Technical Service Bulletin

48 Steering column clicks when it is adjusted vertically

48 22 25 2064535/2 April 28, 2022. Supersedes Technical Service Bulletin Group 48 number 21-11 dated September 16, 2021, for reasons listed below.

Figure 1. Lower pin/hinge – steering column.

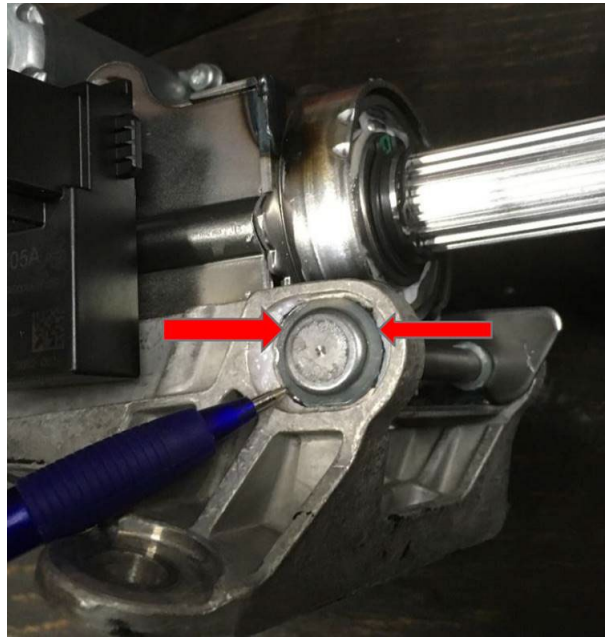
- Noises can be reproduced.
- The noise comes from the pin/hinge area of the steering column

Steering column was assembled under tension.

Figure 2. Steering column bolts.

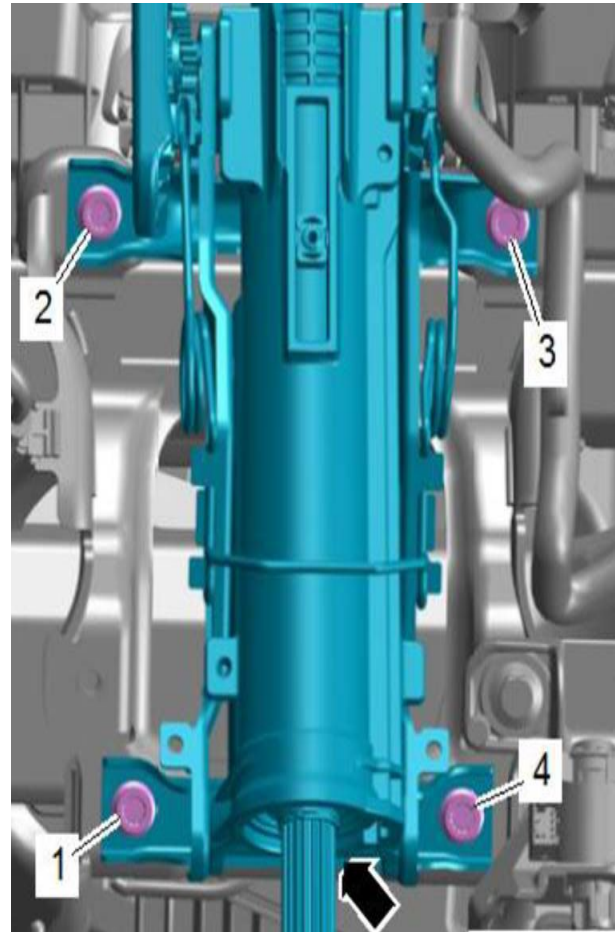
Replace the bolts marked in the (Figure 2) according to the instructions in Elsa at Repair Manual, *Chassis >> 48 Steering >> Steering Column*.

- It is crucial to follow the tightening sequence and torque specification exactly.
- Use new bolts only.
